BOARD OF ZONING APPEALS STAFF REPORT

Agenda Item: BZA 23-014

Application Type: Developmental Standards Variances

Summary: Nicholas Georgiou for ONSI (orthopedics) is seeking six Developmental Standards Variances: Building setbacks, Building materials buildout, Entry standards, Off street parking location, Screening, and Sidewalks at 9900 Columbia Avenue.

Image 2 Phased Development.

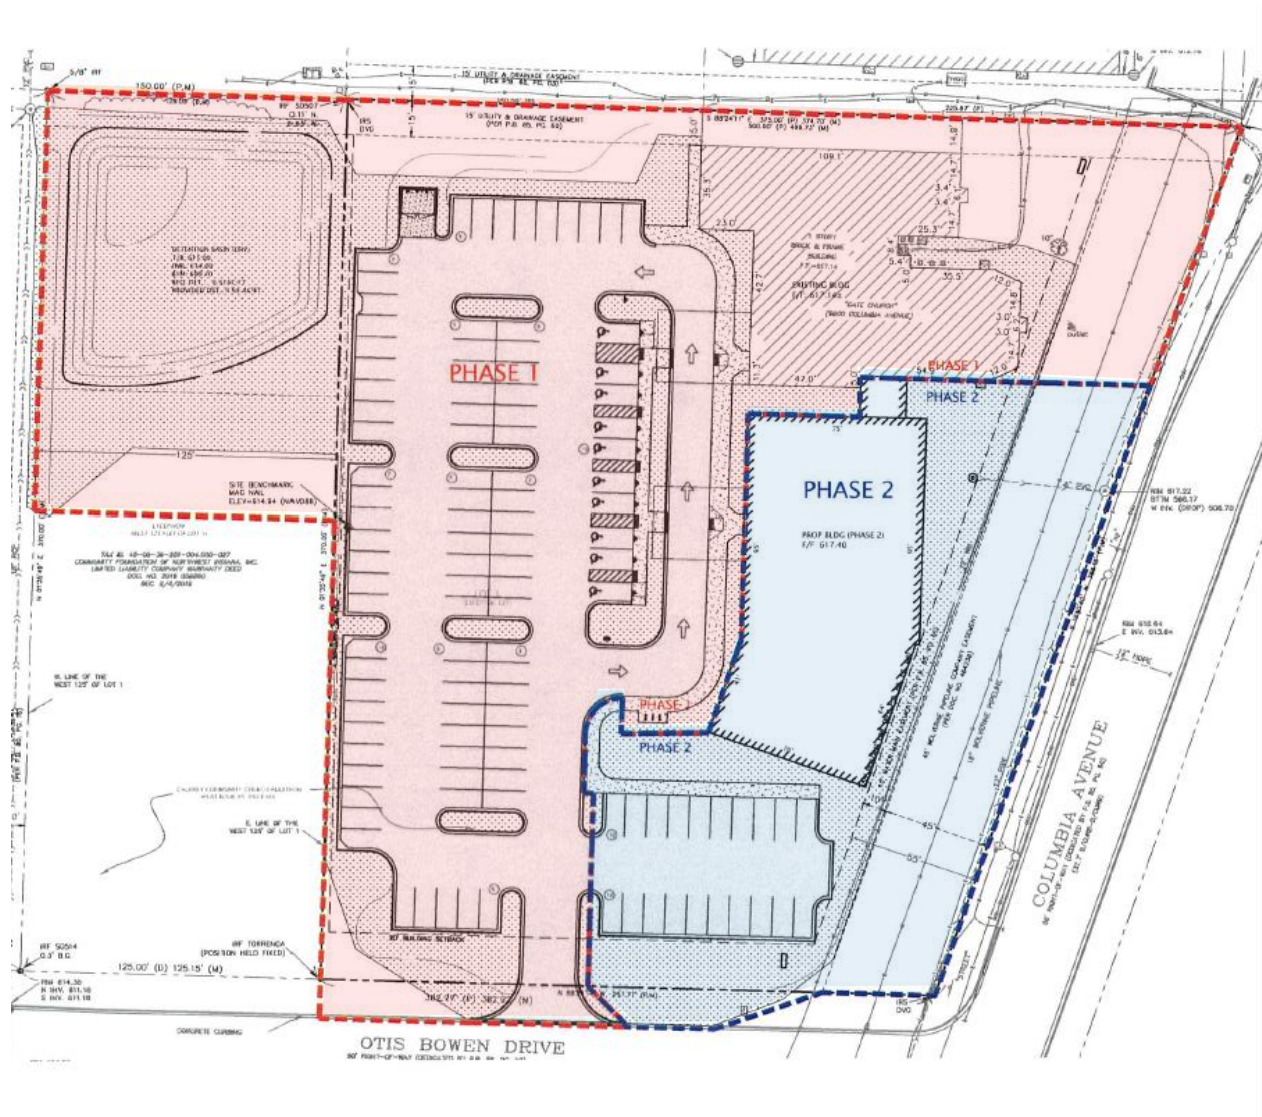
The proposed renovation and expansion are planned for in two phases. In phase 1 ONSI is proposing to renovate the existing 9,844 SF religious use structure into a medical and office facility, expand the existing 48 space parking lot with an additional 44 spaces, and create a half-acre off-site detention area. Phase 2 consists of a proposed 9,750 SF building addition for medical and office use and expand the parking lot with an additional 20 spaces (see Image 2).

1.) **26-6.405. A-7 DISTRICT STANDARDS, Setbacks-Principal Building** (MZC pg. 125)

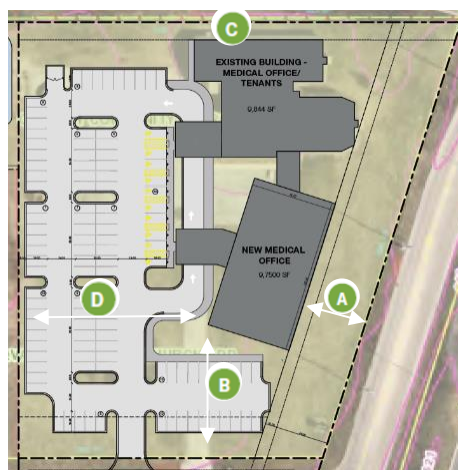
PROPOSED:

Front Setback, Principal 55 FT

Front Setback, Primary 124 FT

Side Setback (Existing) 15 FT

Rear Setback (Existing) 147.5 FT

2.) **26-6.405. A-7 DISTRICT STANDARDS, Building Standards,** (MZC pg. 126)**REQUIRED:****Building Materials**

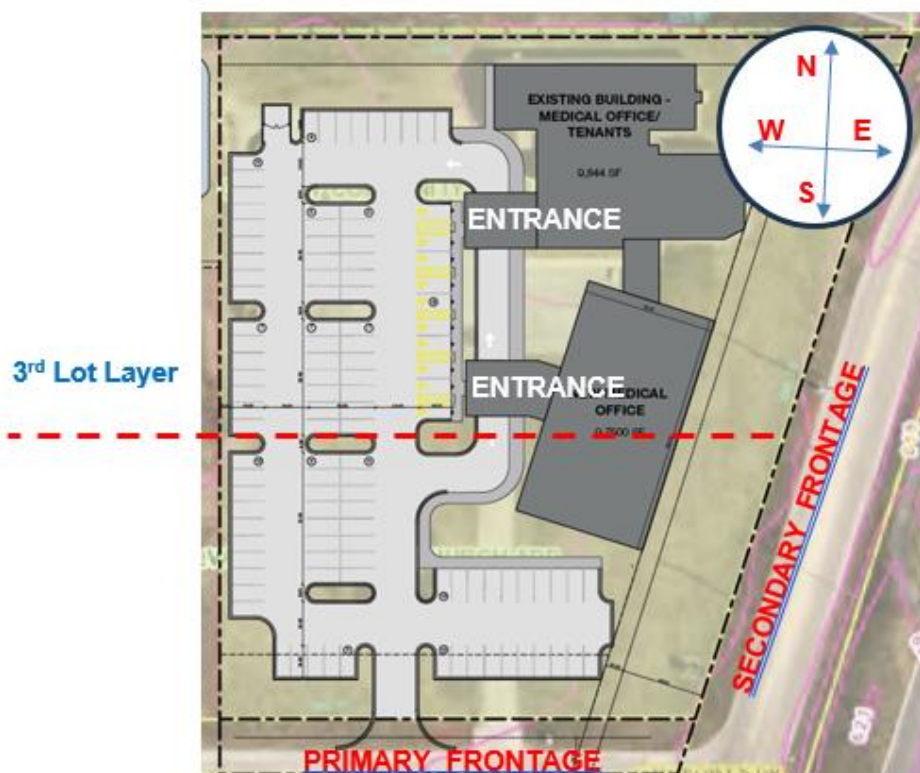
PROPOSED:

Use of E.I.F.S

33%

3.) 26-6.405. A-7 DISTRICT STANDARDS, Building Standards (continued), Entrances (MZC pg. 126)REQUIRED:PROPOSED:**Building Standards (continued)****Entrances**

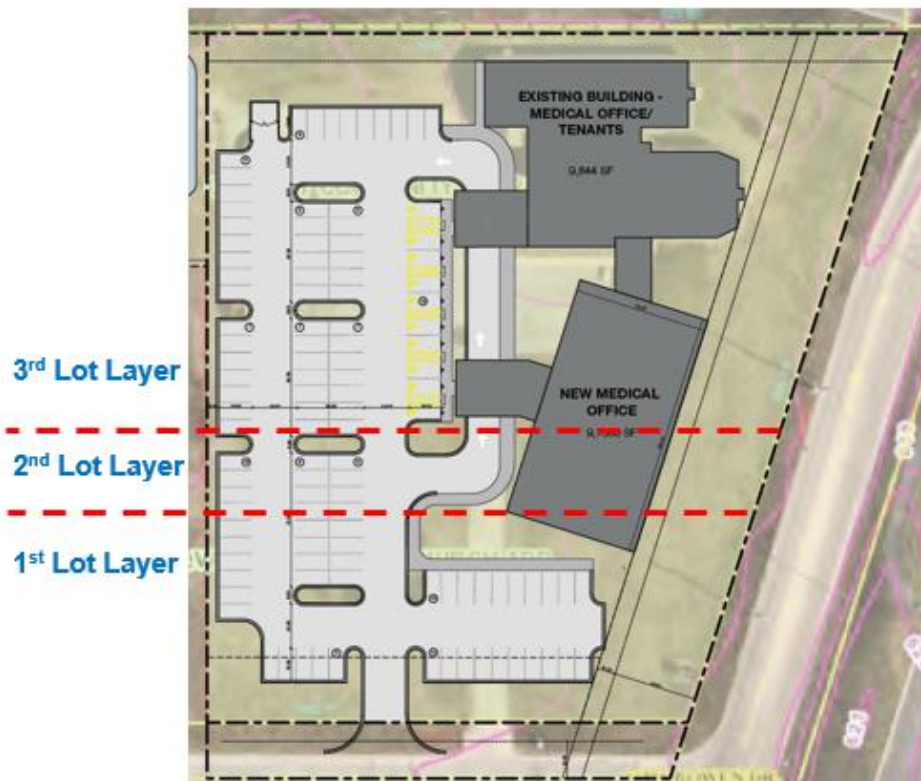
Proposed Main Entrance is not at the Façade of the Principal Frontage or at corner.

The proposed Main Entrance(s) are located facing west, towards the interior of the 3rd Lot Layer

4.) 26-6.405. A-7 DISTRICT STANDARDS, (MZC pg. 128)**REQUIRED :****Vehicular Parking Requirements**Off-Street Parking
Location

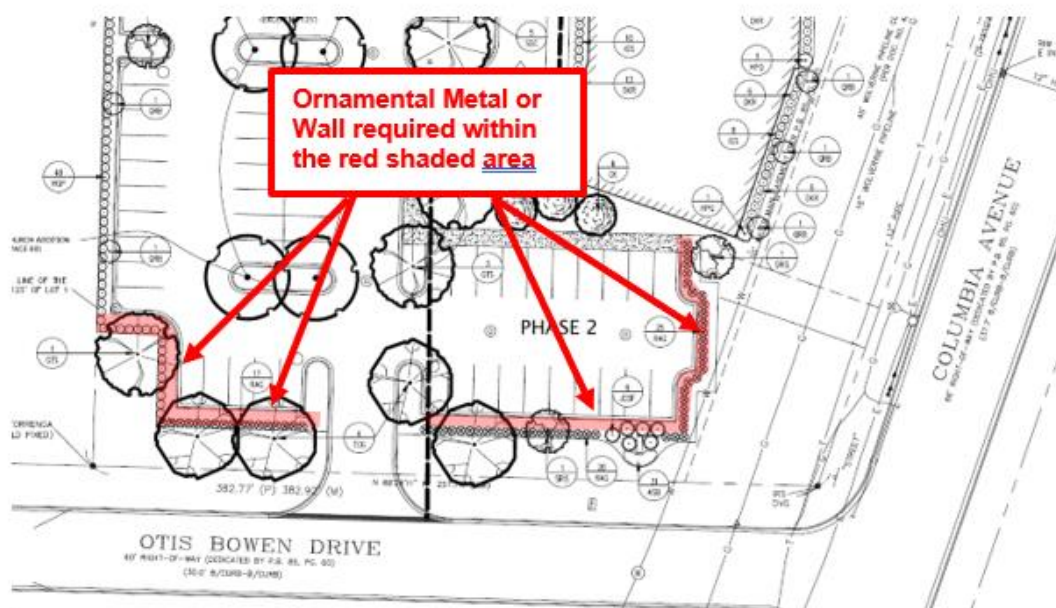
NP**PROPOSED:**Parking in the 1st
Lot Layer
